## PIC18F87J50 Family Data Sheet Errata

### Clarifications/Corrections to the Data Sheet:

In the Device Data Sheet (DS39775B), the following clarifications and corrections should be noted. Any silicon issues related to the PIC18F87J50 family will be reported in a separate silicon errata. Please check the Microchip website (www.microchip.com) for any existing issues.

FIGURE 19-10: I<sup>2</sup>C™ SLAVE MODE TIMING (TRANSMISSION, 7-BIT ADDRESS)

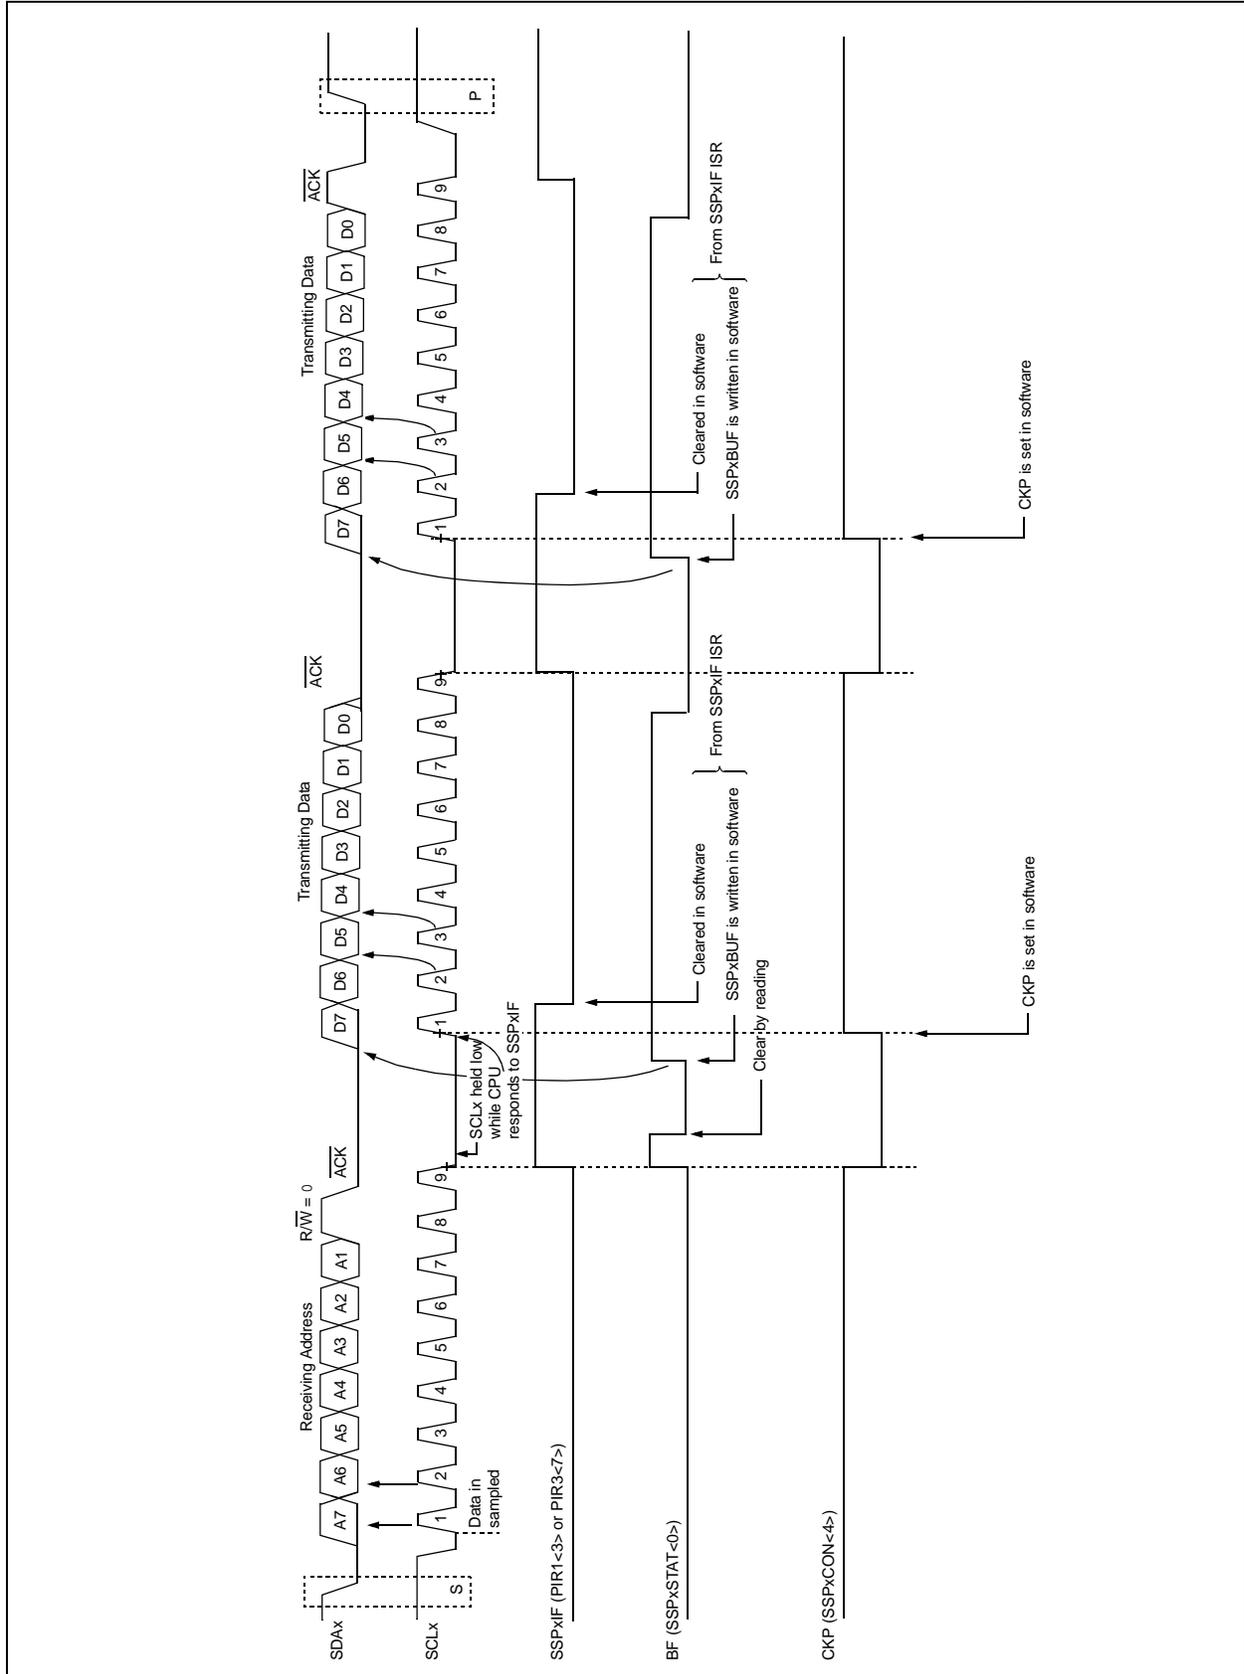
## 6. Module: Figure 19-10: I<sup>2</sup>C™ Slave Mode Timing (Transmission, 7-Bit Address)

On page 252, the figure is replaced with the new timing diagram provided in Figure 19-10.

FIGURE 19-24: I<sup>2</sup>C™ MASTER MODE WAVEFORM (RECEPTION, 7-BIT ADDRESS)

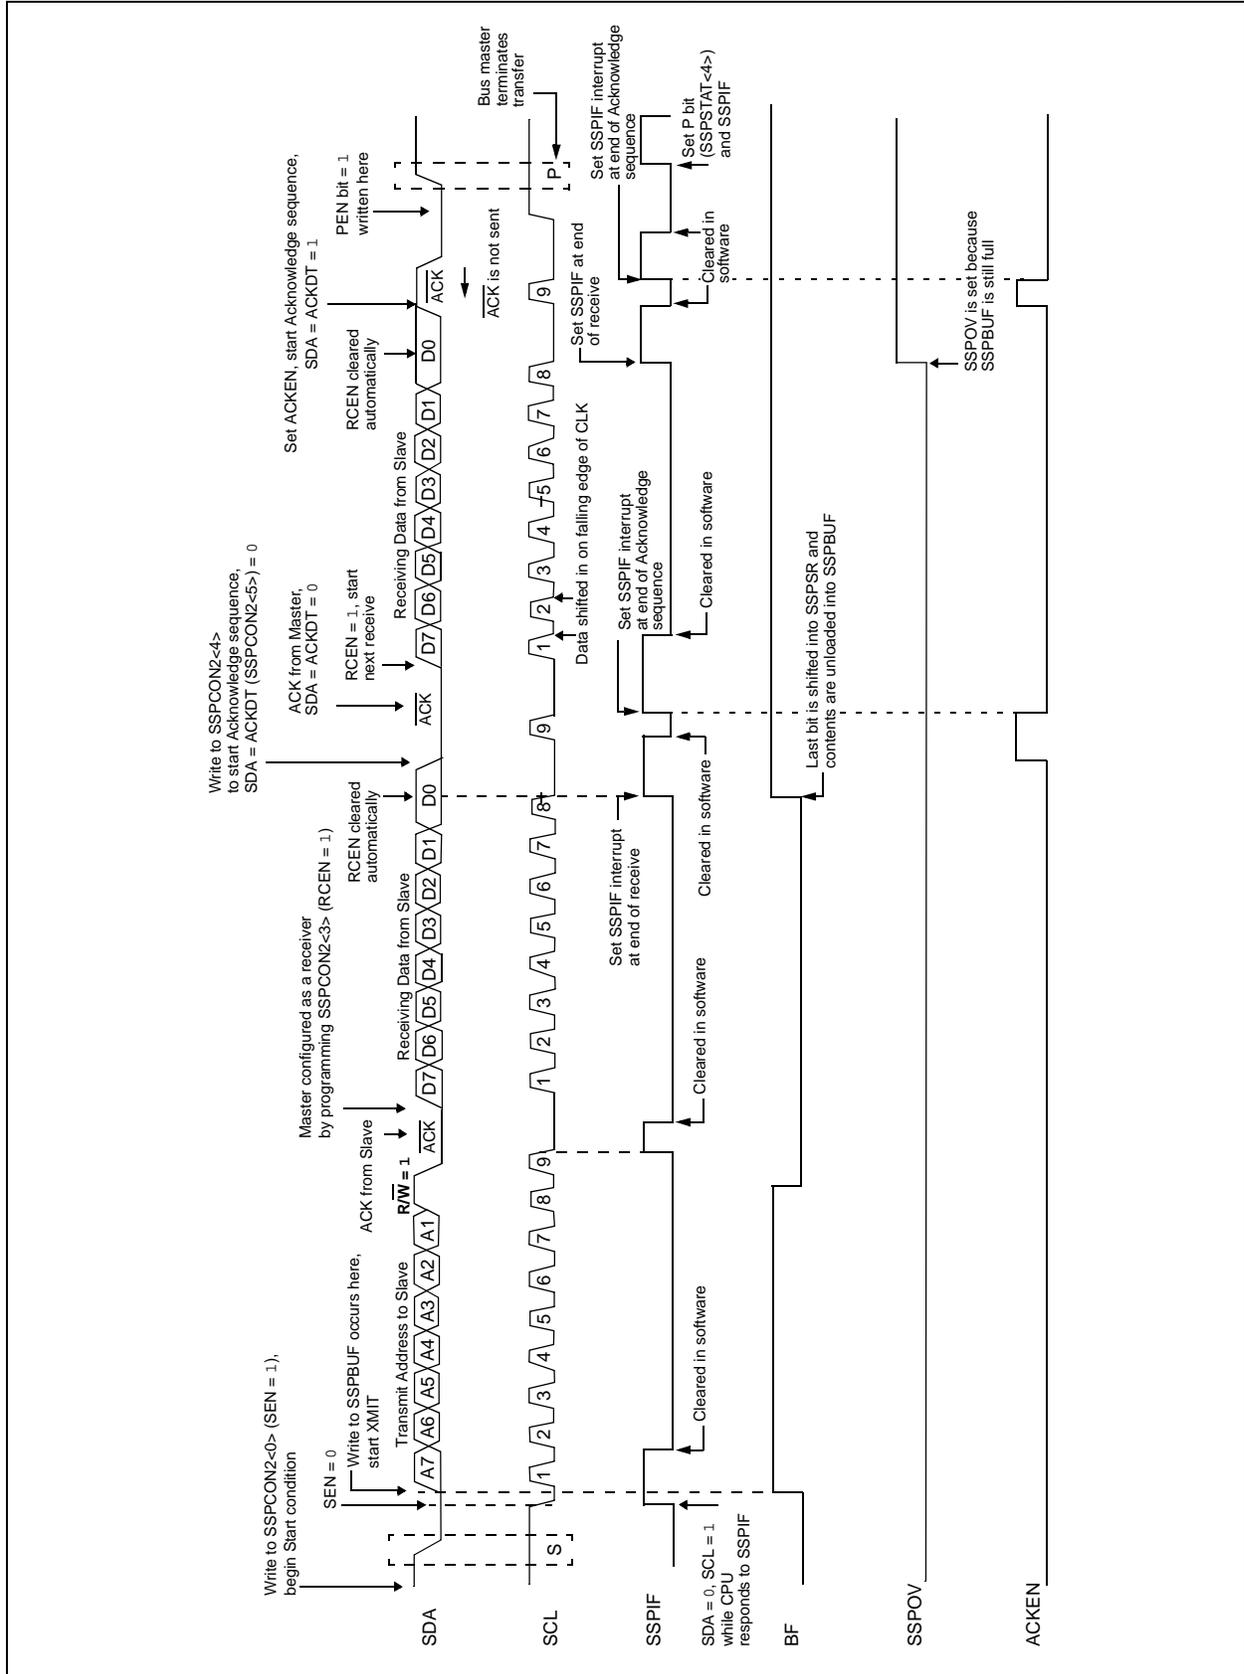
## 7. Module: Figure 19-24: I<sup>2</sup>C™ Master Mode Waveform (Reception, 7-Bit Address)

On page 269, the condition ( $R/\overline{W}$ ) when the Acknowledge signal (ACK) is received from the slave, after transmitting the address to the slave, is changed to '1'. The changed value is indicated in bold text in Figure 19-24.
